Office Action Summary

10/662,277

HUANG, CHIEN-KAI

Diagram 1. Figure 5 of Mitsuhashi.

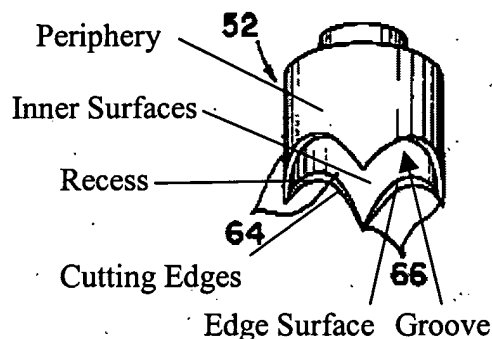
4. Claims 1 and 2 are rejected under 35 U.S.C. 103(a) as being unpatentable over Mitsuhashi (4,491,261) in view of Fish (395,320). Mitsuhashi discloses cylindrical body 52, which includes the portion of element 50 that is integrally formed inside cylindrical body 52 in figure 4; first end is top part of body 52 in figure 5; second end is bottom part of figure 5; terminal ends 64; three terminal ends in column 4, lines 13-16; tip portion 66; all of the elements as shown in diagram 1 below; longitudinal axis C; first angle and second angle are shown in the cutaway view of figure 4; first angle is shown as 45 degrees; second angle is shown as 0 degrees; upper curved surface and curved area are portion 50, which is formed inside element 52; upper curved surface is adjacent the axis C; curved area is adjacent element 52. Mitsuhashi discloses everything, but does not disclose tip portions being located at parallel planes. However, Fish teaches tip portions at parallel planes in figure 3. It would have been obvious to provide tip portions at parallel planes in Mitsuhashi as taught by Fish in order to provide a successively acting punch that can pass through several thicknesses of paper. See column 2, lines 60-72 in Fish.
